Re: NCIRT Review and USACE Approval of the Owls Den Draft Mitigation Plan; SAW 2013-00717;
EEP IMS #95808

SUBJECT: Owls Den- NCIRT Comments During 30-day Mitigation Plan Review

NCEEP Project Name: Owls Den Stream and Wetland Mitigation Site, Lincoln County, NC

Subject: Response to IRT Comments and Final Mitigation Plan Submittal
Owl's Den Stream and Wetland Mitigation Site, Lincoln County
Catawba River Basin – 03050102
HUC# 03050103 Expanded Service Area
EEP Project ID No. 95808 / USACE Action ID#2010-00717
Contract # 5150

Planting

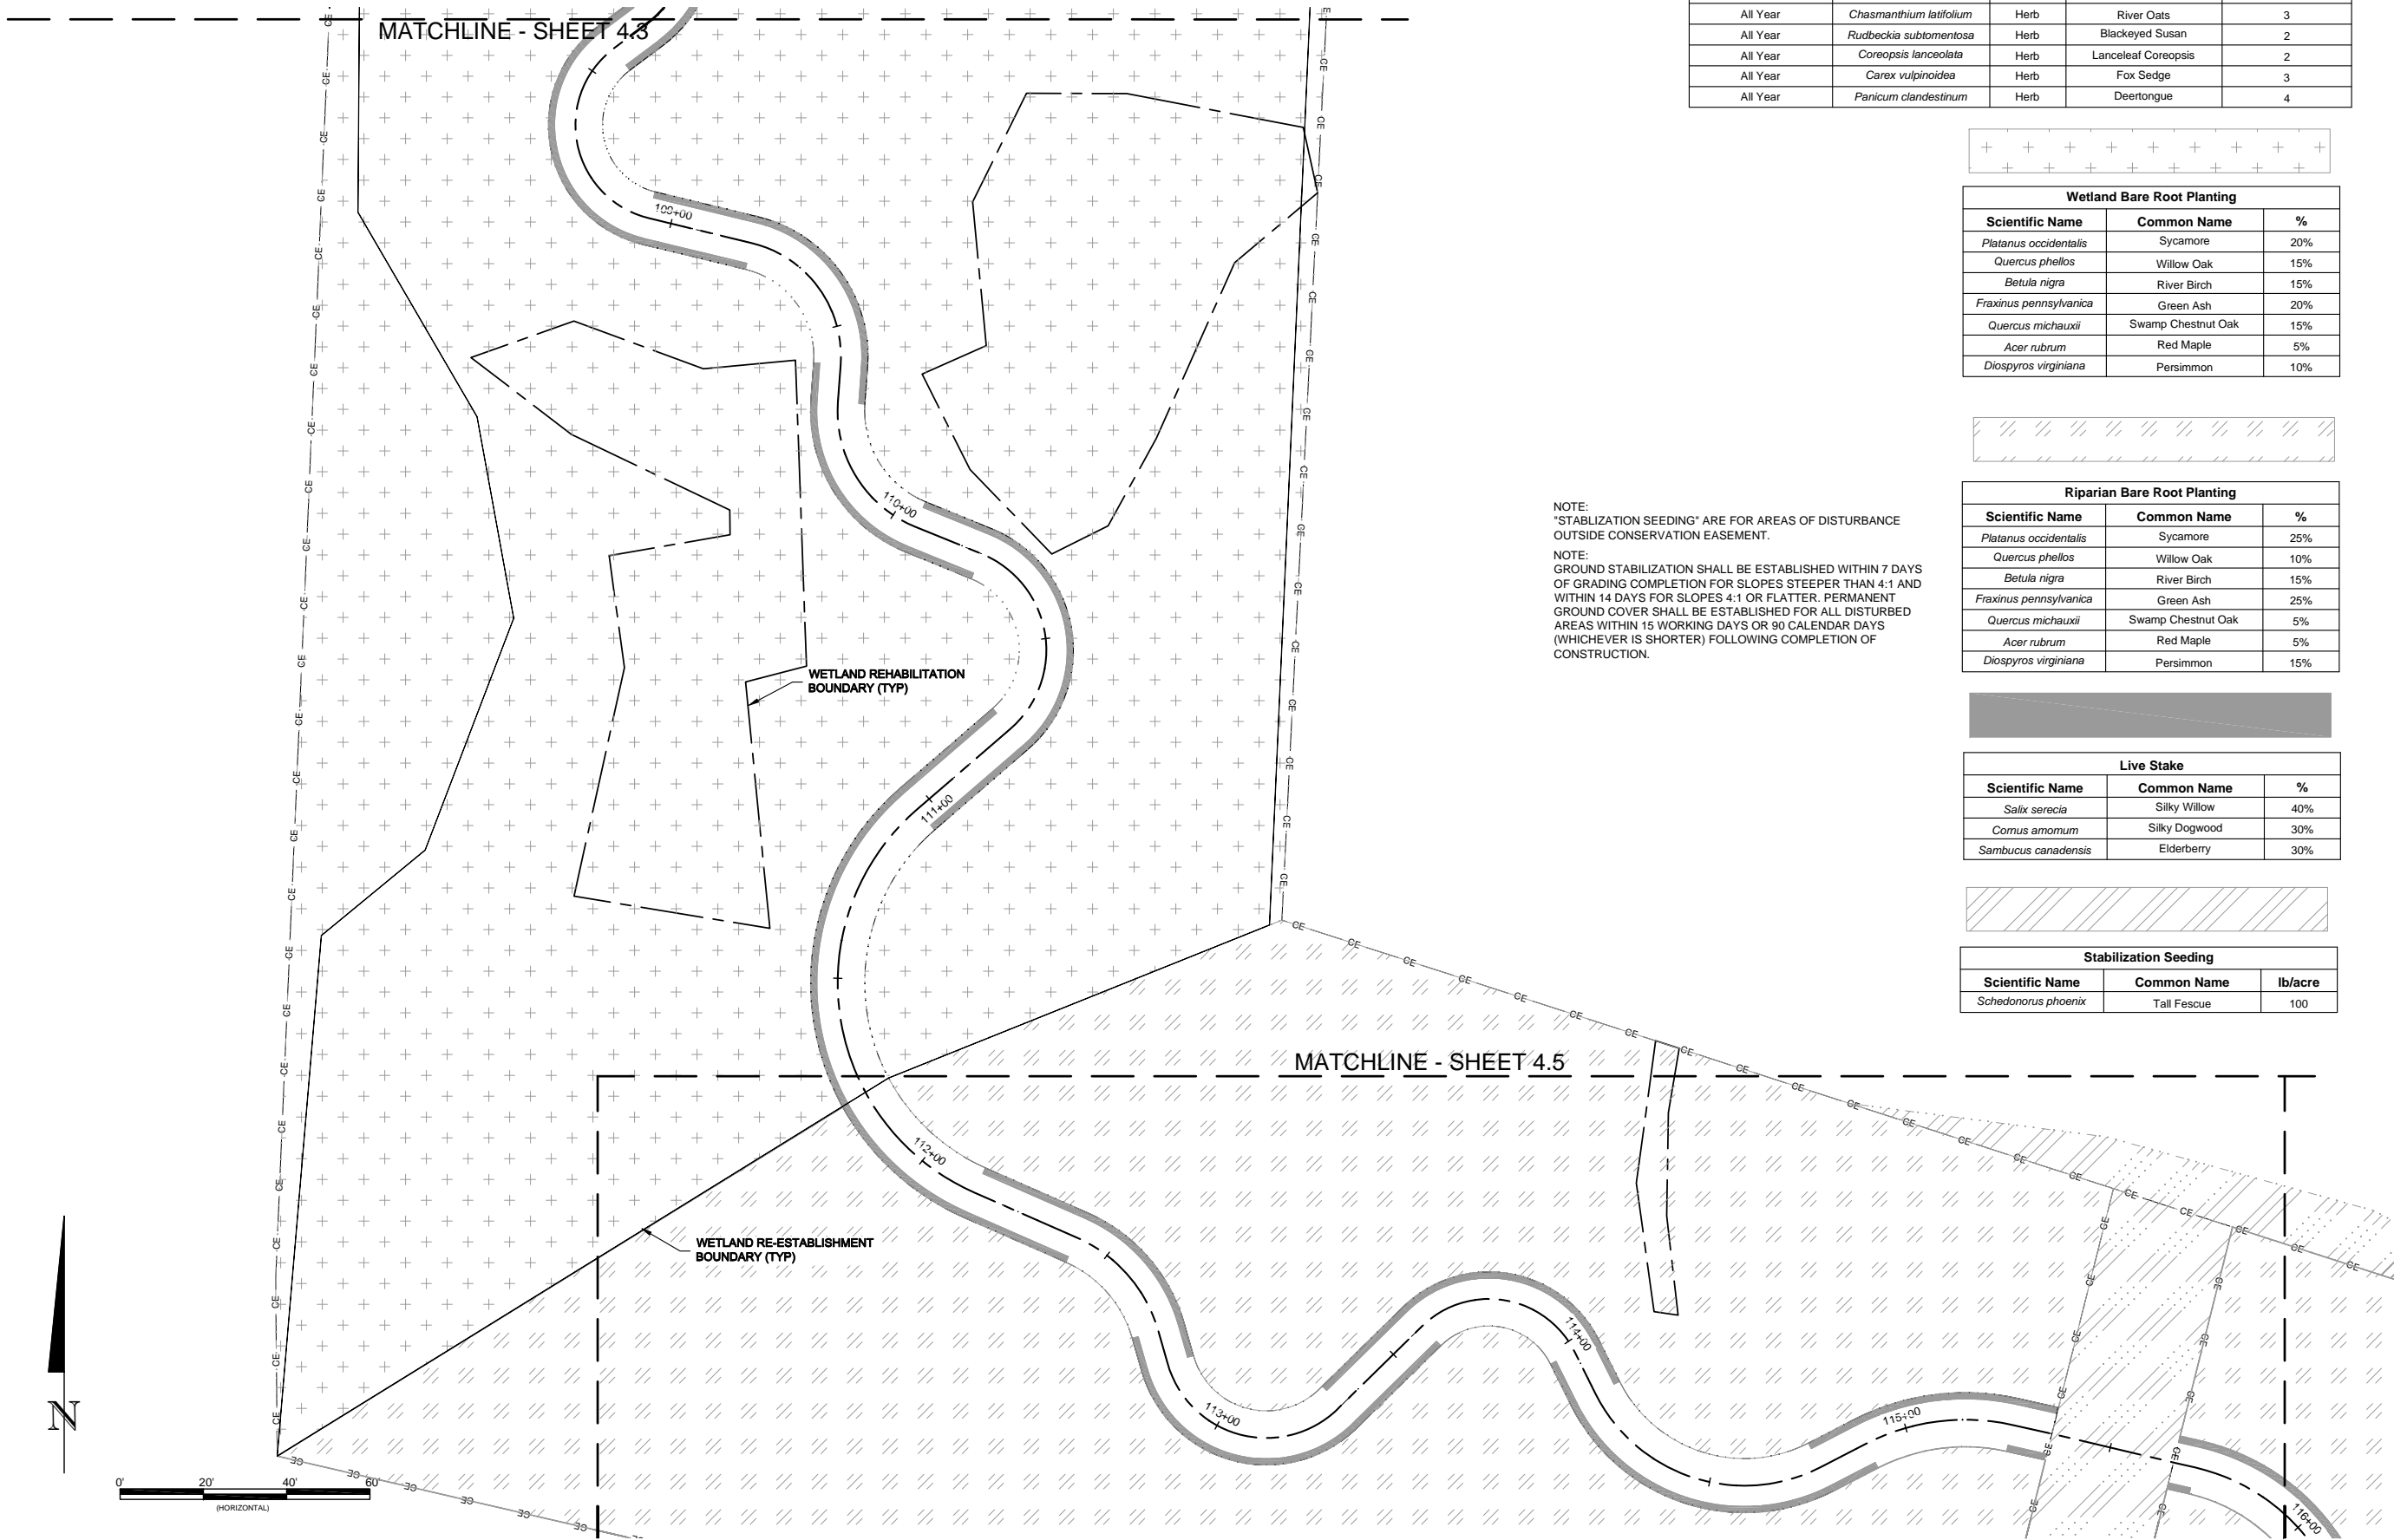
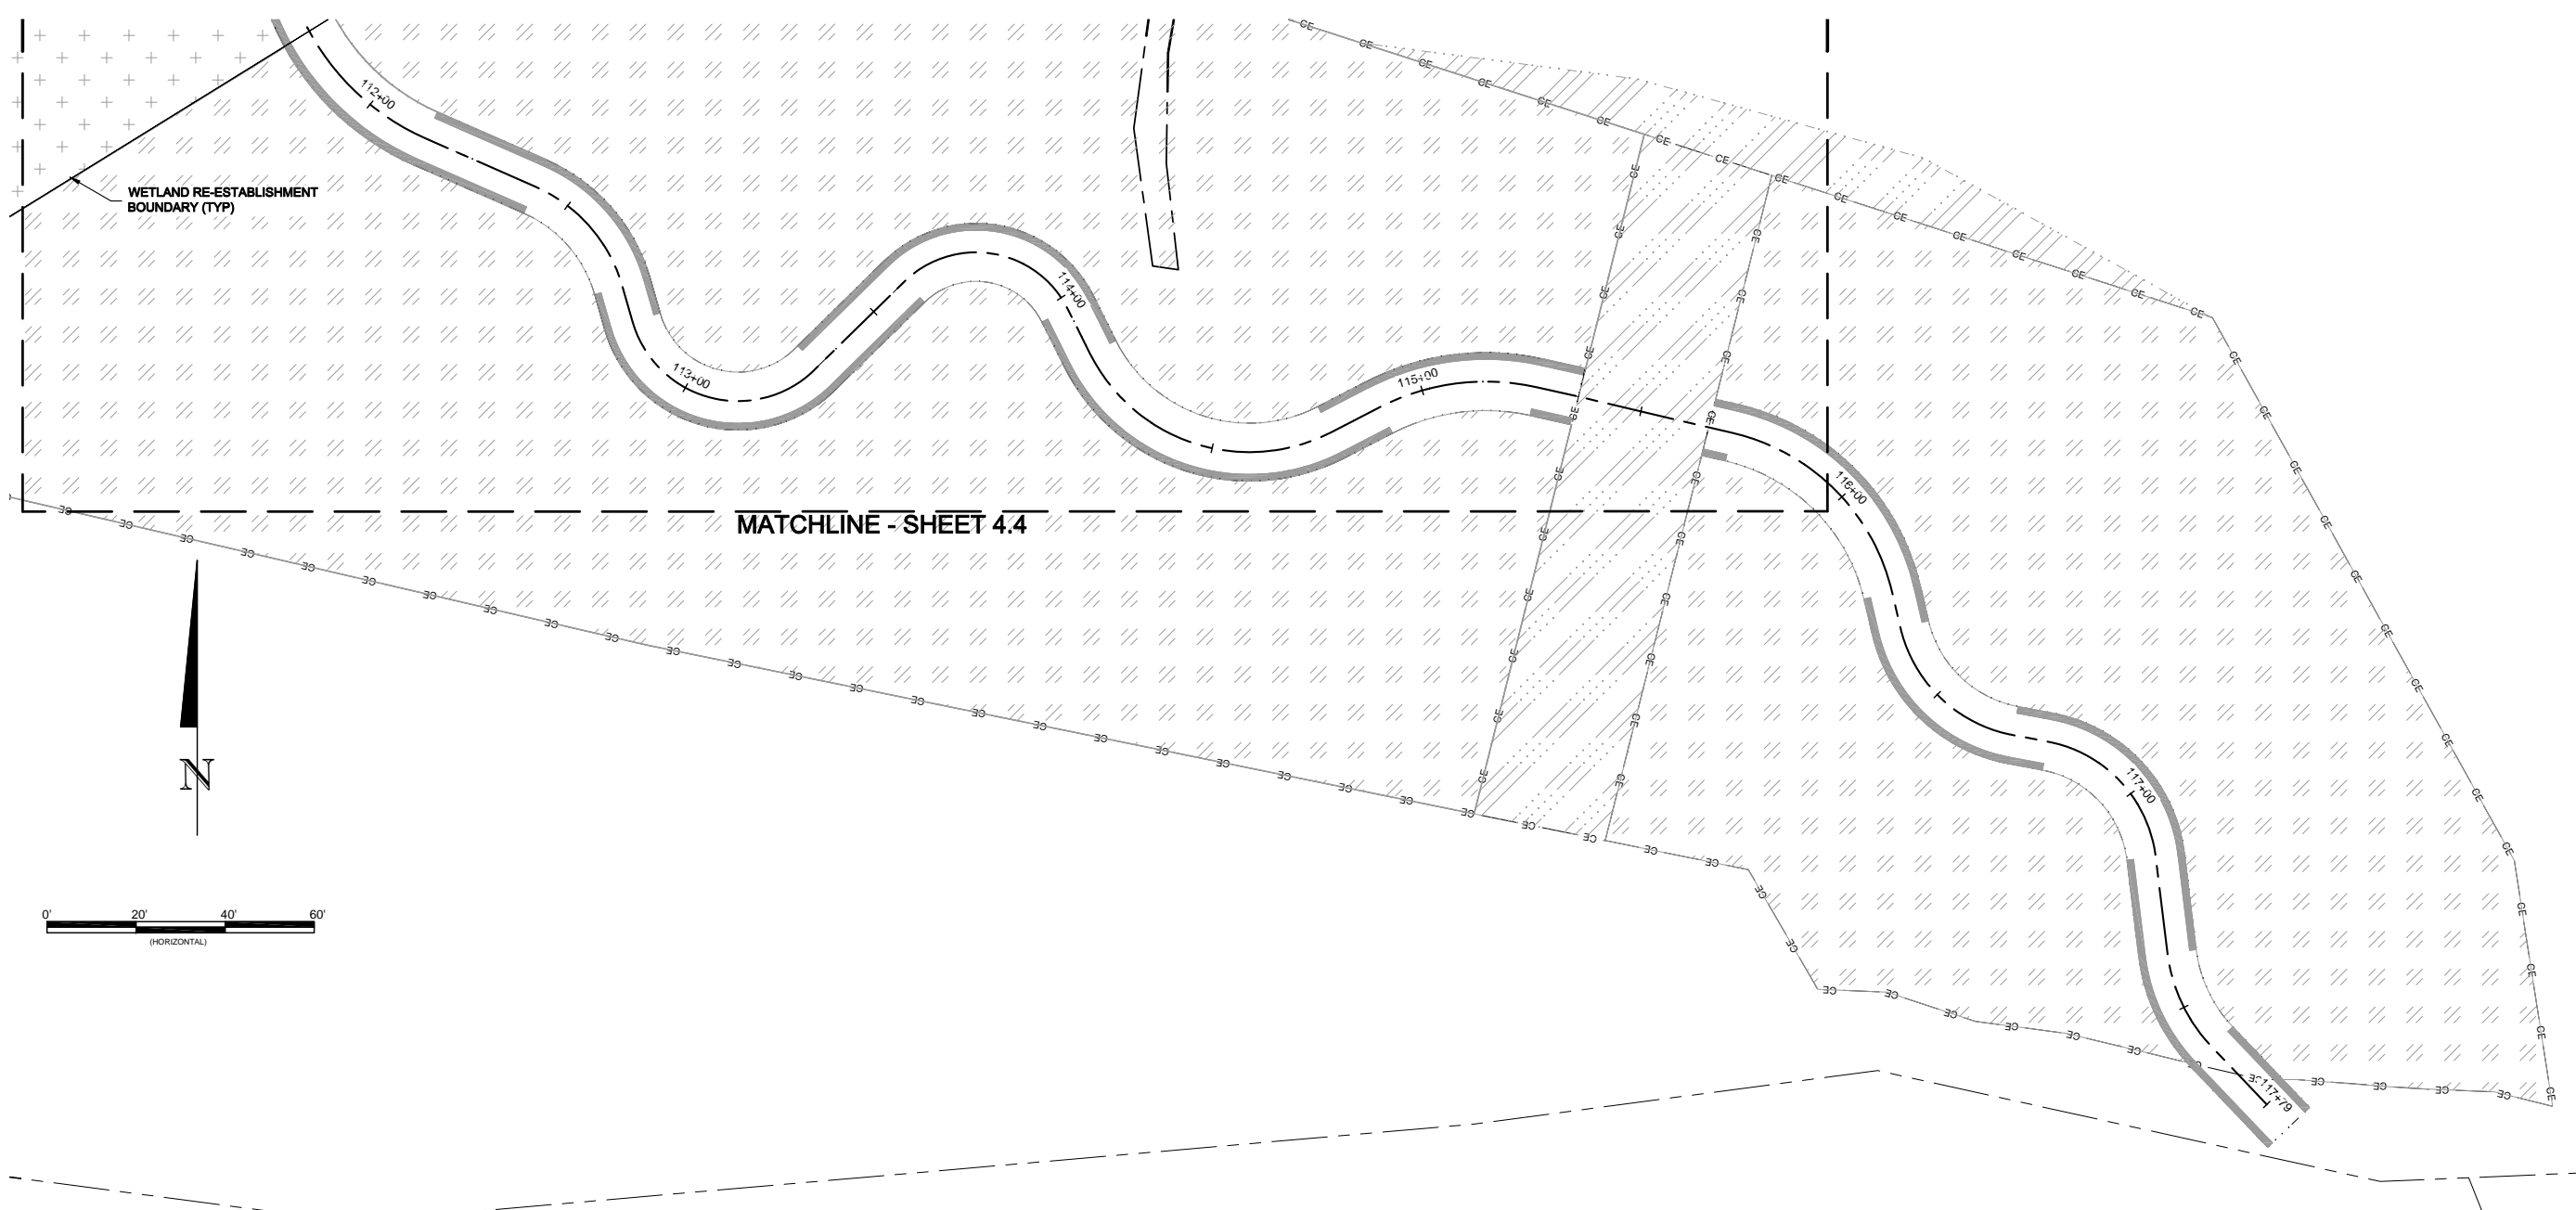
2. *The planting plan includes red maple. Red maple is a prolific volunteer species that has naturally established itself at most of the mitigation sites visited. Please omit this species from the planting plan, or at most, reduce it from 15% to 5% of the total planted stems.*

7. *Trees Planted: The assemblage of trees designated for wetland and riparian bare root planting (pages 345-9/Sheets 4.1-5) includes red maple (*Acer rubrum*) at 15%. I would recommend that if red maple needs to be included (and I don't think it does based on its ability to rapidly volunteer open sites) that its proportion be lessened to no more than 5% of all species planted.*

Red maple was reduced to 5% in the riparian and wetland bare root planting zones (Sheets 4.1 - 4.5). Sycamore and green ash species were increased to 25% of the riparian planted stems and 20% of the wetland planted stems.

Red maple was reduced to 5% in the riparian and wetland bare root planting zones (Sheets 4.1 - 4.5). Sycamore and green ash species were increased to 25% of the riparian planted stems and 20% of the wetland planted stems.
